**Addendum No. 5  
to  
Contract Documents**

McKinley Street Interceptor

City of Hollywood

City Project No. 07-7059

### **SHEET S-3 – INTERCEPTOR BOX EXCAVATION DETAILS SHEET 1**

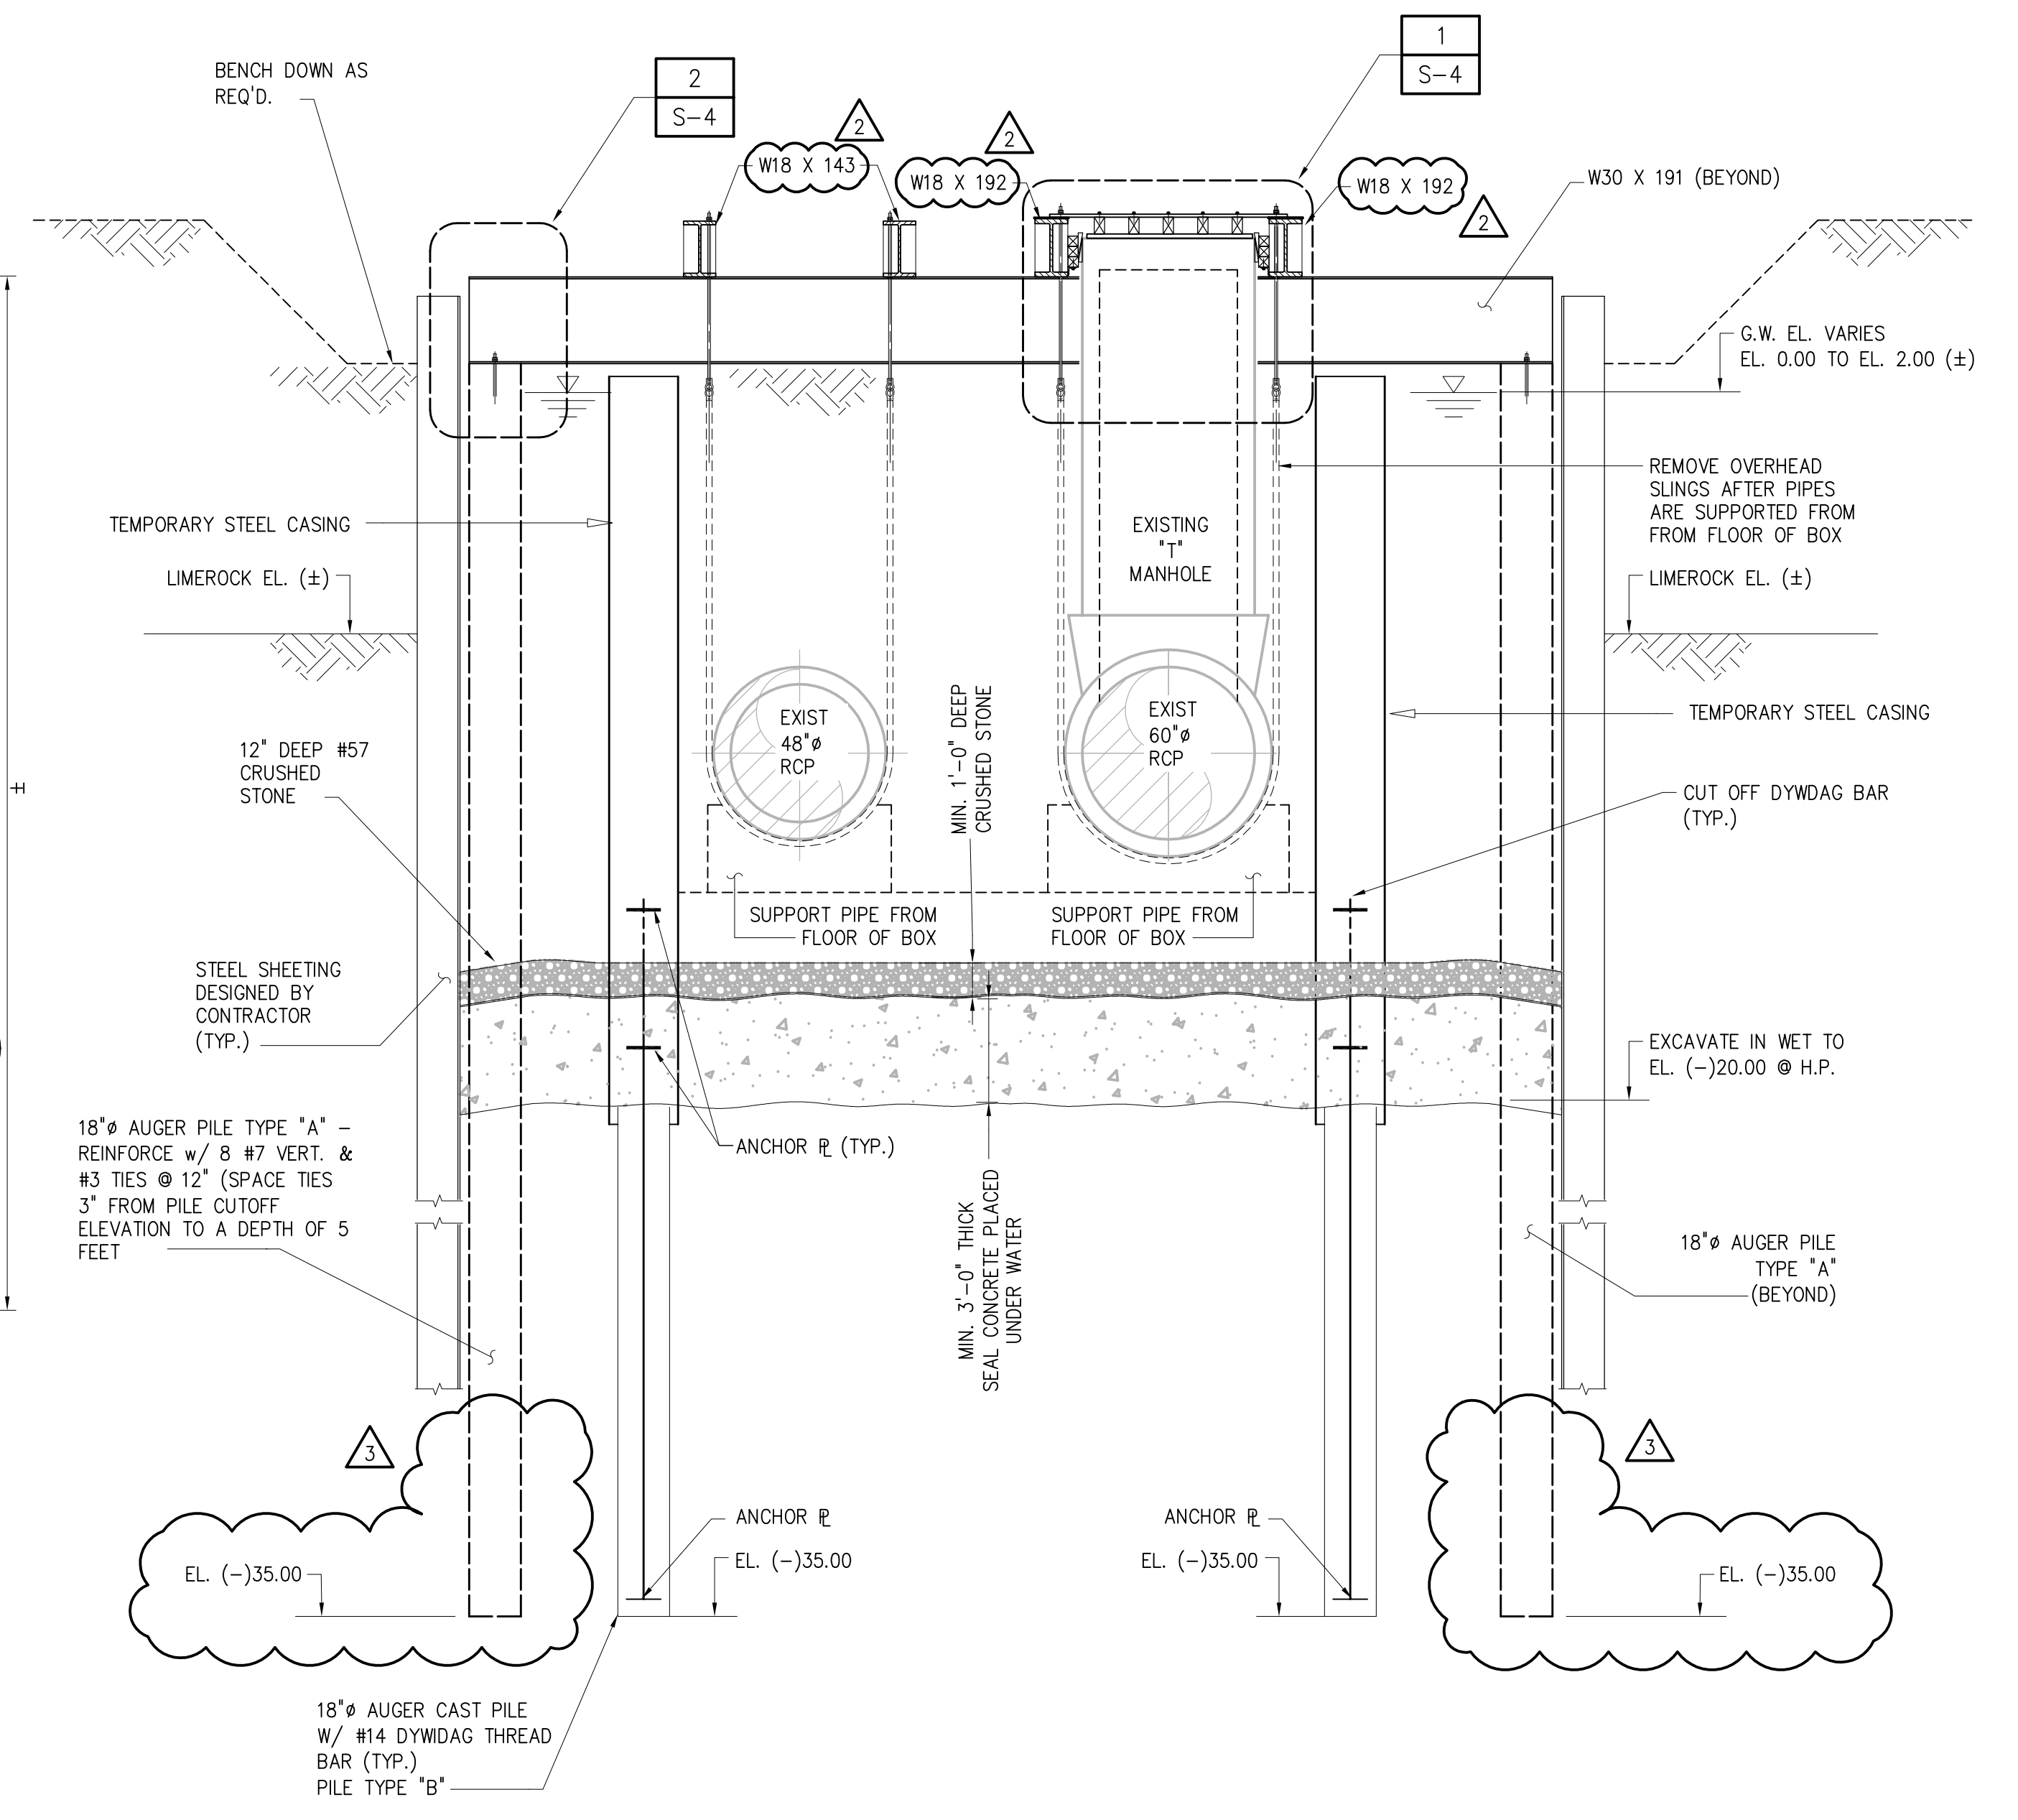
1. Delete this sheet in its entirety and replace it with attached Sheet S-3.
